SCHICK GEOTECHNICAL, INC.

October 4, 2007
SG 6164-W

Response to City Review Letter
Portion of Lot 17, Tract 11357
7810 Torreyson Drive
Los Angeles, California

GEOLOGY AND SOILS REPORT CORRECTION LETTER

Gross Stability Analysis - Taylor's Method

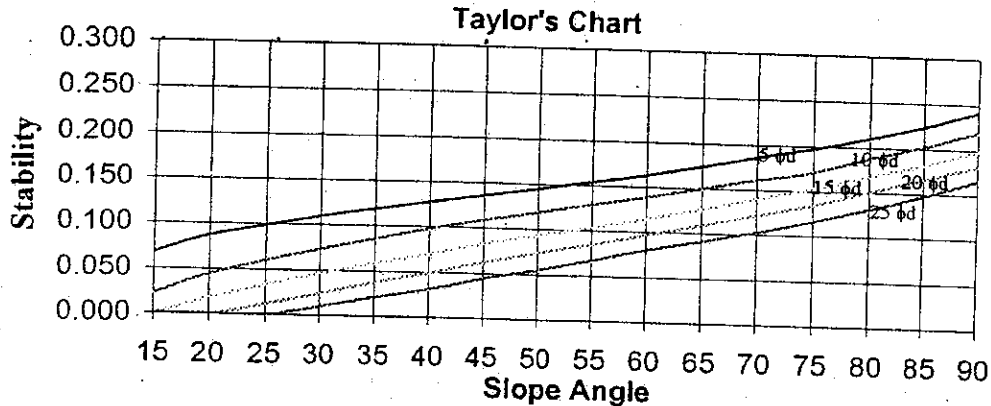
6. Provide slope stability analyses to demonstrate that any proposed road cuts in bedrock with a gradient of 1:1 have the minimum factor of safety as required by code.

Response to Review Item 6. The enclosed calculations indicate that 1:1 cut slopes within bedrock will have a factor of safety in excess of 1.50.

The calculations indicate that 45° degree slopes in Shale are grossly stable with a factor of safety greater than 1.5 up to 89.07 feet high. Therefore, the existing slopes up to 50 feet high consisting of Shale are grossly stable.
